Product Change Notification / SYST-22OZTS834

ERRATA - dsPIC33EPXXXGP50X, dsPIC33EPXXXMC20X/50X, and PIC24EPXXXGP/MC20X Family Silicon Errata and Data Sheet Clarification

Description of Change: Updated silicon issue 30.

dsPIC33EPXXXGP50X, dsPIC33EPXXXMC20X/50X and PIC24EPXXXGP/MC20X Family Silicon Errata and Data Sheet Clarification

FIGURE 1: TIMING DIAGRAMS FOR CENTER-ALIGNED AND EDGE-ALIGNED MODES

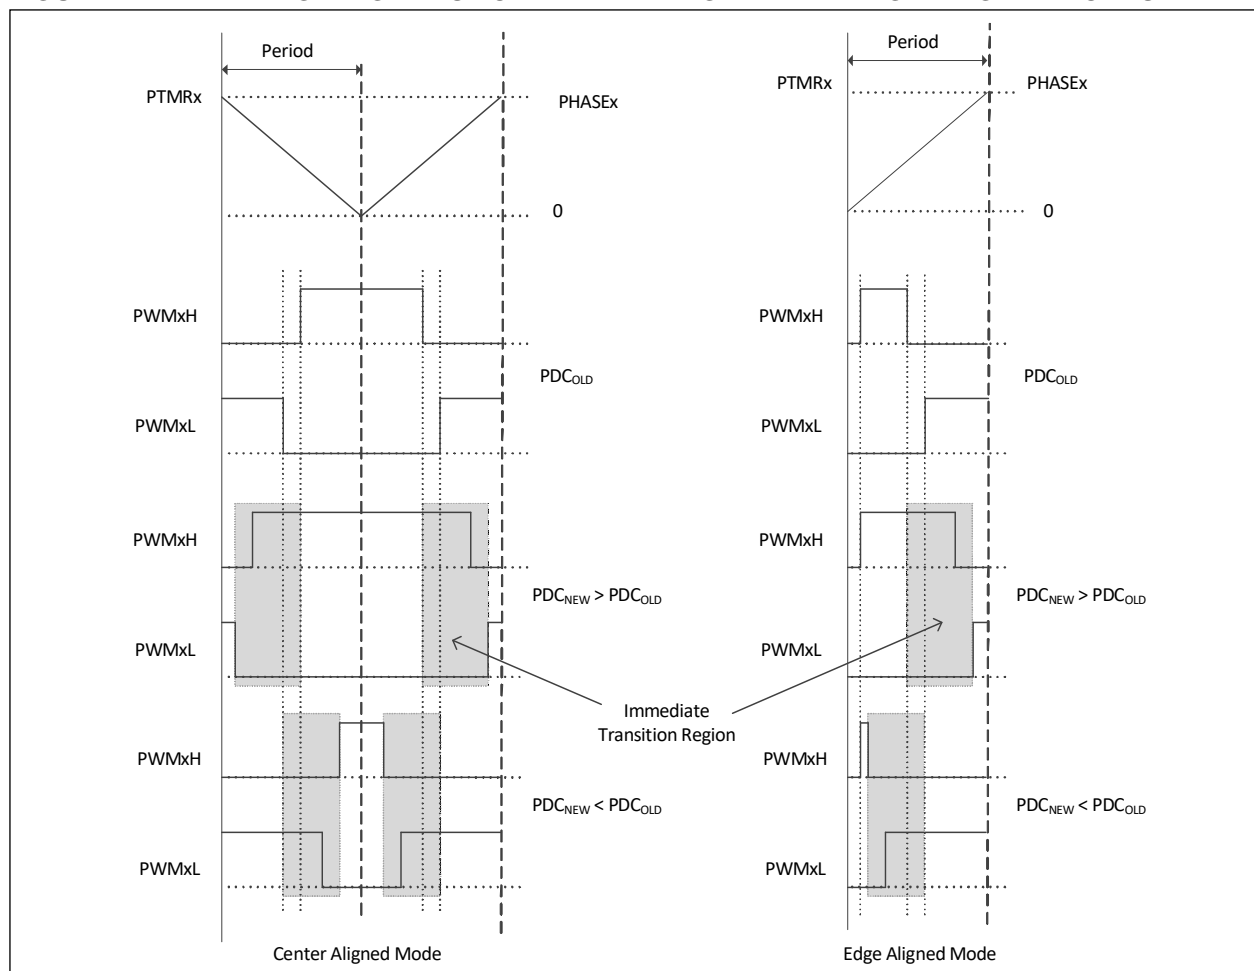
time base, will determine if the PWMxH and PWMxL outputs make an immediate transition. PWMxH and PWMxL outputs make an immediate transition if the Duty Cycle register is written with a new value, PDC_{NEW}, at a point of time when the PWM time base is counting a value that is in between PDC_{NEW} and PDC_{OLD}. Additionally, writing to the Duty Cycle register, close to the instant of time where dead time is being applied, may result in a reduced dead time effective on the PWMxH and PWMxL transition edges.

In Figure 1, if the duty cycle write occurred in the shaded box, then PWMxH and PWMxL will make an immediate transition without dead time.

FIGURE 2: PWM TIMING DIAGRAM

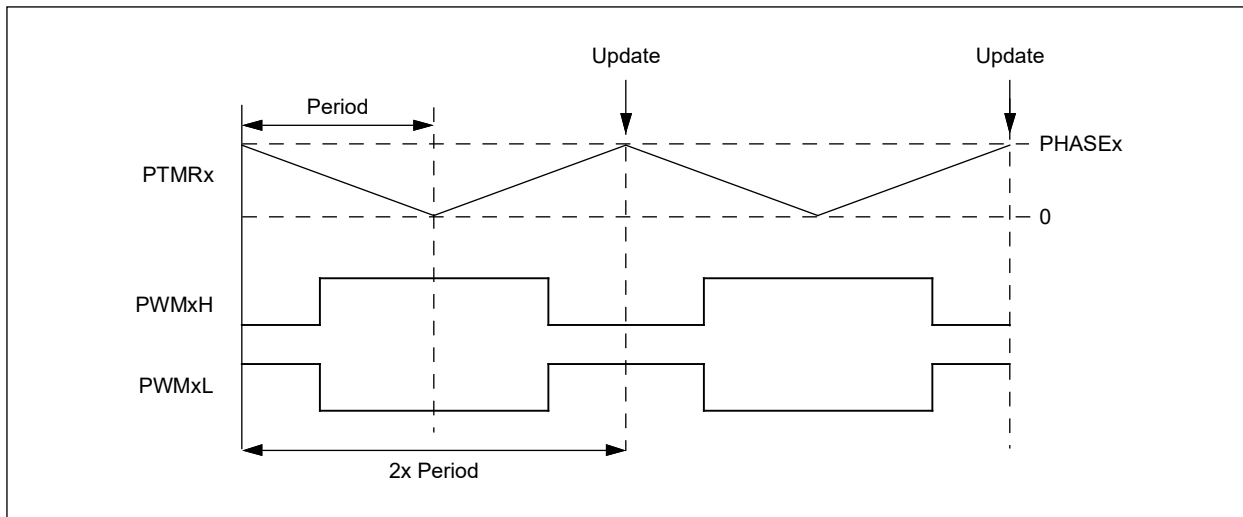
In Center-Aligned mode, updates to active `MDC/PDCx/ALTDTRx/PHASEx` registers occur only once every two PWM periods; that is, when the PWM timer matches the `PHASEx` register. In other words, the double update feature is not available. Figure 2 illustrates this relationship.

FIGURE 3: CORRECT AND INCORRECT POSITION COUNT CAPTURES

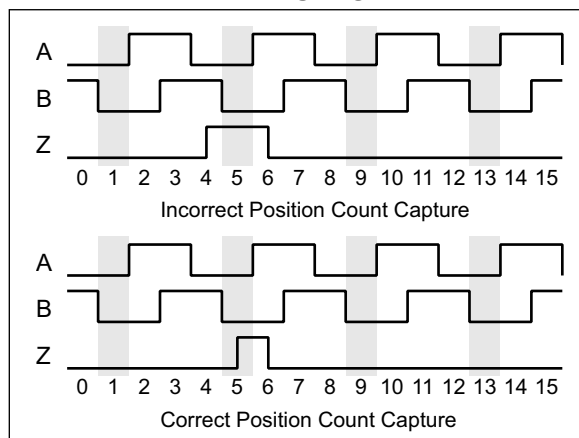
When index count position capture is being used ($QE1IOC.QCAPEN = 1$), the position count may be one more or one less than the correct value, depending on the direction of the count.

This is only observed when the leading edge of the index pulse occurs prior to the leading edge of the index match event. When the index pulse starts after the leading edge of the index match event, the position count is captured correctly.

Figure 3 shows how this occurs. In these cases, Encoder Signals A, B and (index) Z are shown, with the module being configured for index match when A and B are '0'. The effects of a correct and incorrect capture are shown side by side (shaded areas indicate the index match event); the position count is shown along the bottom.

For encoder signals with timing that ensures the index pulse always starts prior to the start of the index match event (i.e., encoders with a non-gated index pulse), measure the direction of the encoder motion. If the encoder is counting up, add one to the captured position count; if the encoder is counting down, subtract one from the captured position count.

For encoder signals where the index pulse leading edge approximately coincides with the start of the index match event (i.e., encoders with a gated index pulse), a small delay can be added to the index pulse, for instance, by using a simple R-C filter.

FIGURE 4: PWM GENERATOR TIMING DIAGRAM

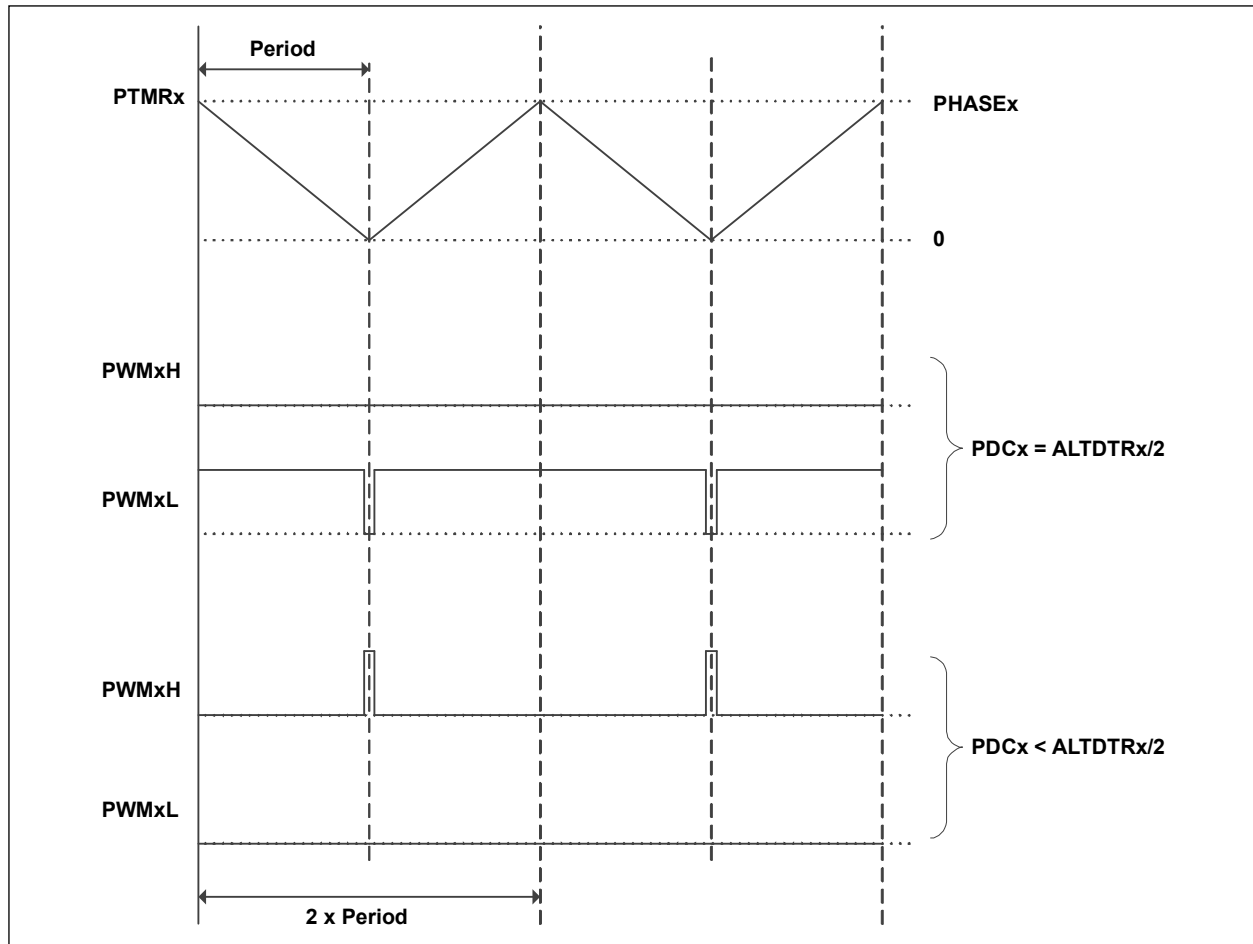
In Center-Aligned Complementary mode with Independent Time Base, if the value in the PDCx register is less than one-half the value in the ALTDTRx register, the PWM generator will force the PWMxL to low, and on the PWMxH, generate pulses of width less than twice the dead time, as shown in Figure 4.

FIGURE 5: ILLUSTRATION OF 1 T_{osc} GLITCH WHEN PWM OVERRIDE IS TURNED OFF

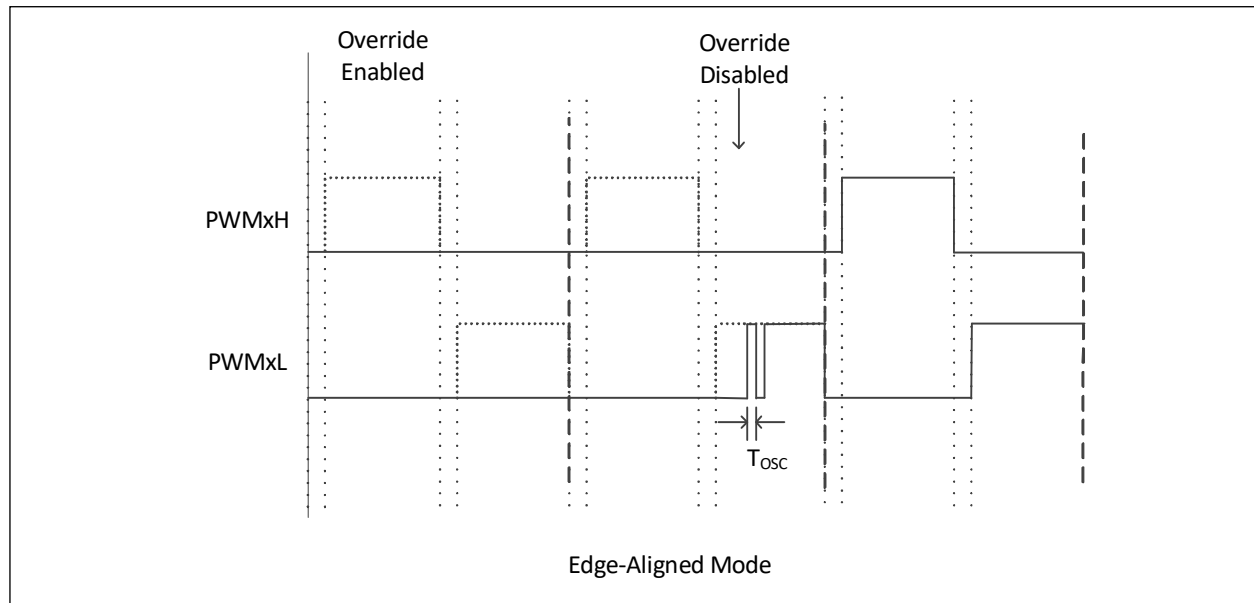
In Complementary mode after the PWMx module is enabled (PTEN = 1), if the PWM override is turned off, a 1 T_{osc} glitch will be present on the rising edge of either PWMxH or PWMxL, whichever occurs first, as shown in Figure 5. The glitch will be present on PWMxH/PWMxL every time the override state is changed from enabled to disabled. The width of this glitch is equal to 1 T_{osc} when PCLKDIV[2:0] = 000; increasing the PWM input clock prescaler setting will increase the width of the glitch accordingly.

FIGURE 6:

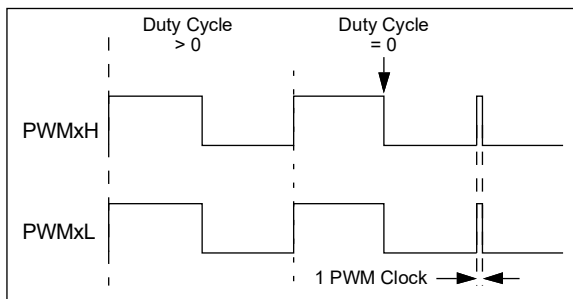
In certain output modes, the PWMx module produces a pulse glitch of one PWM clock in width (Figure 6). This has been observed only when all of the following are true:

- Either Redundant or Push-Pull Output mode is selected (IOCONx[11:10] = 10 or 01);
- Immediate Update is disabled (PWMCONx[0] = 0); and
- The value of the current Duty Cycle register (either the PDCx or MDC register, as determined by PWMCONx[8]) is updated to zero from any non-zero value.

The pulse glitch has been observed to occur at the beginning of the following PWM boundary period.

FIGURE 7:

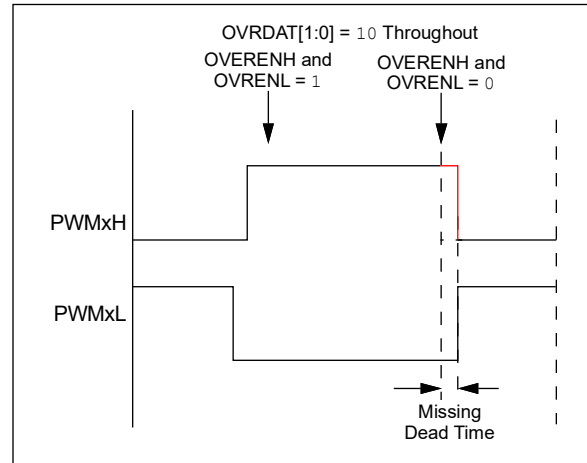
- Output override synchronization is configured to occur on the CPU clock boundary (IOCONx[0] = 0);
- Both PWMxH and PWMxL overrides are enabled prior to the event (OVRENH and OVRENL are both '1'), and
- Both overrides are disabled (OVRENH and OVRENL are both '0') at the instant the dead time should be asserted (Figure 7).

This has been observed in both Center-Aligned and Edge-Aligned modes.

FIGURE 8:

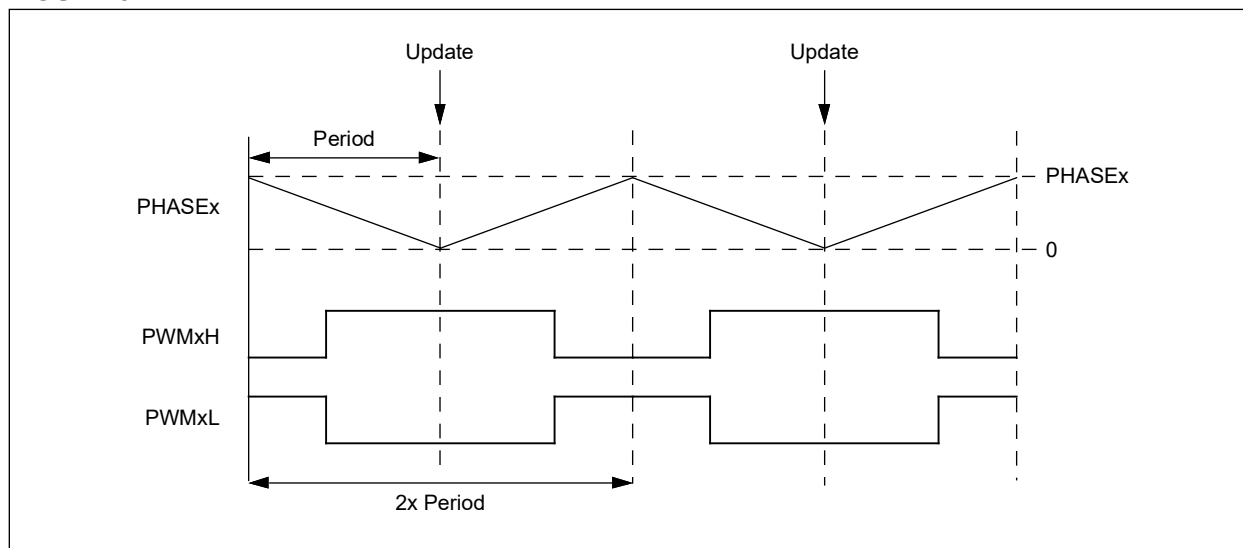
In Center-Aligned Complementary mode with Independent Time Base, updates to the PHASEx register take effect in the middle of a center-aligned PWM cycle, as shown in Figure 8. This occurs only when the Immediate Update feature is disabled (IUE = 0). If Immediate Update is enabled (IUE = 1), the PHASEx register updates will take effect immediately.

FIGURE 9: SIMPLIFIED BEHAVIOR

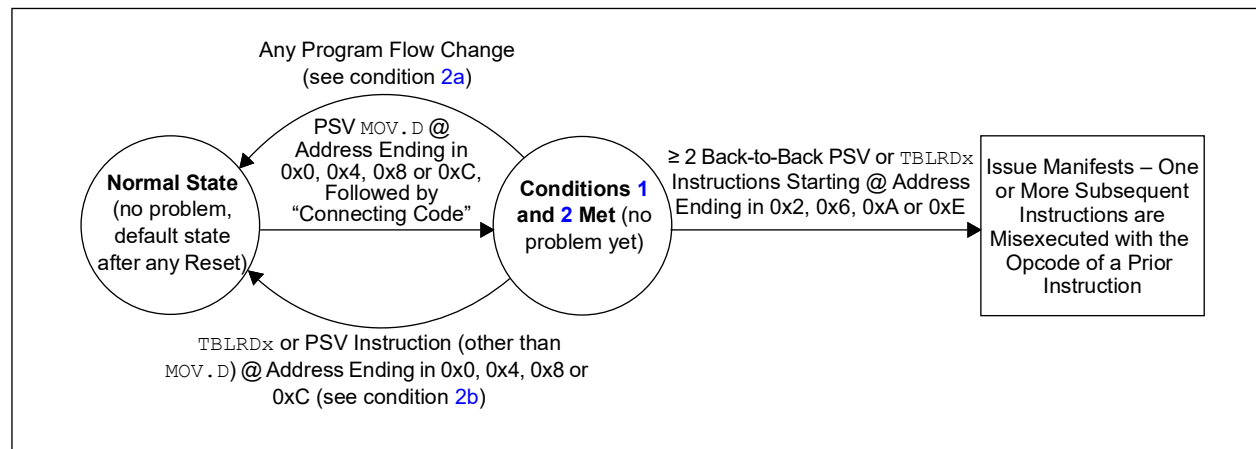
3.	≥ 2 back-to-back PSV or <code>TBLRDx</code> instructions are executed (following the code of condition 2), where the first of the back-to-back instructions is located at an address ending in 0x2, 0x6, 0xA or 0xE.

[Figure 9](#) provides an example of the effective behavior.

1. All instances of PSV `MOV.D` can be replaced with two PSV `MOV` instructions instead. Non-PSV `MOV.D` instructions acting on RAM/SFRs do not need to be modified; or
2. If not already present, a program flow change instruction (such as `BRA $+2`) can be inserted above back-to-back data Flash read sequences; or
3. Back-to-back data Flash read instruction sequences can be broken up by inserting a non-Flash read instruction (such as a `NOB`) in between the Flash read instructions; or
4. The alignment of the code can be shifted to avoid the required opcode location addresses.

C code built with MPLAB® XC16 Compiler, Version 1.32, or later, implements the work around by default. However, if the application uses Assembly language routines, these should be manually modified to implement the work around. Additionally, if precompiled libraries are used, these should be built with XC16 Version 1.32 or later. For additional information, please visit: www.microchip.com/erratum_psrds_psrds.
